Change of KEK SCT DAQ cable - Support card connection

Oct 24 2000

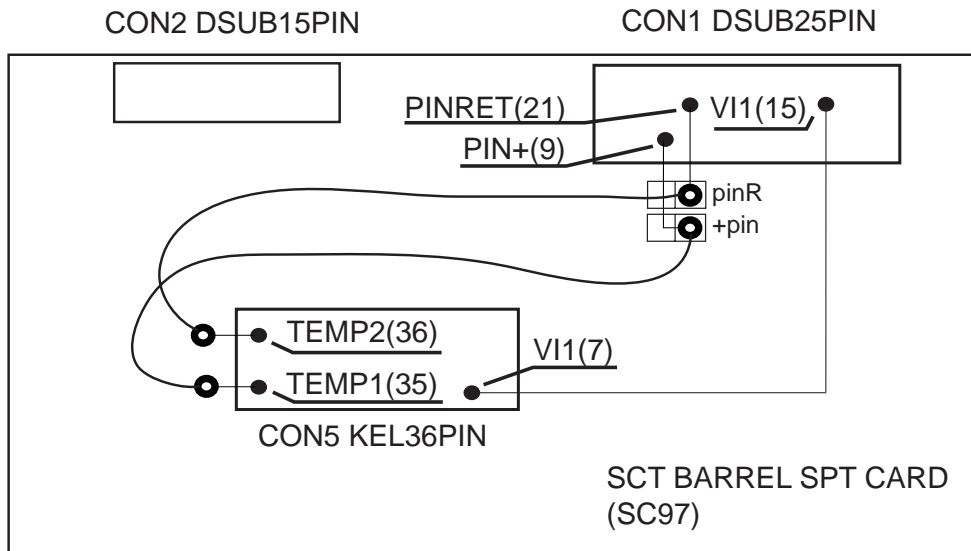
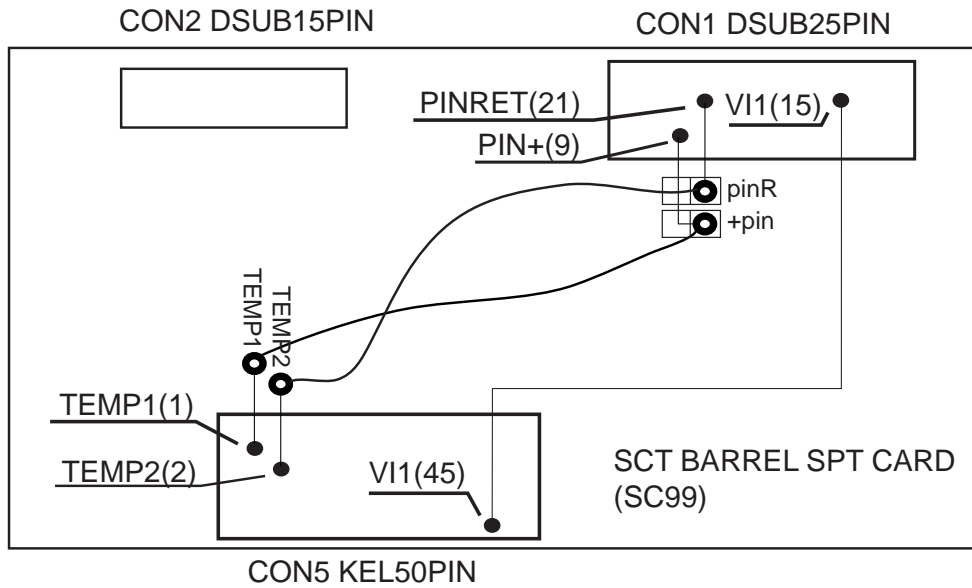
The thermister pins are not connected in the KEK cable and the KEK support card. Since the (9)PIN+ and (21)PIN(RET) are connected, SC99 and SC97 have been modified to use these pins for T1 and T2. In the DAQ side, however, because of SCTLV the proper pin must be assigned to T1 and T2. thus, the cable connector of the DAQ side are now modified so that the (9)PIN+, (21)PIN(RET), and (15)VI1 of the support card side are connected to the (6)T1, (7)T2, and (8)T3(RET). The connector where the (6)T1, (7)T2, and (8)T3(RET) connections are made is marked "T1, T2, T3" for identification.

T1 and T2 have been connected to pinR and +pin in the support card(SC99,SC97).

Note: In future, the T1 and T2 connection in the support card should be made to (6)T1 and (7)T2 AND the cable connector of the support card side should be modified accordingly, in other to minimize confusion.

Next modification in both the DAQ side and the support card side the proper pins must be connected T1, T2, and T3(RET). Then, TEMP1 and TEMP2 connected to (6)T1 and (7)T2 directly. And (15)VI1 must also be connected (8)T3(RET) directly.
